SLAC Final Traffic Comments

TO: Nell Donaldson, Planner
FROM: Lauren Swett, PE
DATE: December 27, 2017
RE: St. Lawrence Arts Center, Level III Site Plan Application

Woodard & Curran has reviewed the Level III Site Plan Application for the proposed redevelopment project at the St. Lawrence Arts Center in Portland, Maine. The project involves the construction of a building addition to add a performing arts center to the existing church building.

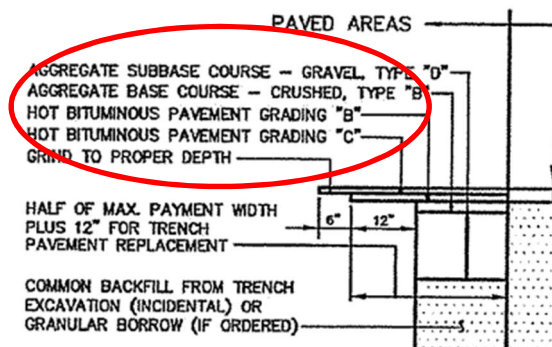
- 2) *The Applicant should provide a detail for bituminous pavement repair in accordance with the City of Portland's Technical Standards.* Applicant has noted that this detail is included as part of the pipe trench installation detail on sheet C2.1. Note (per screen shot to the right) that this detail does not include material thicknesses. It references that depths are determined by street classification, but this information is not provided anywhere on the plans.

Attached are the drawings showing the items in Lauren's letter. We have removed the note, added a stabilized construction entrance and added the pavement thicknesses. I believe they have been uploaded to the website as well.
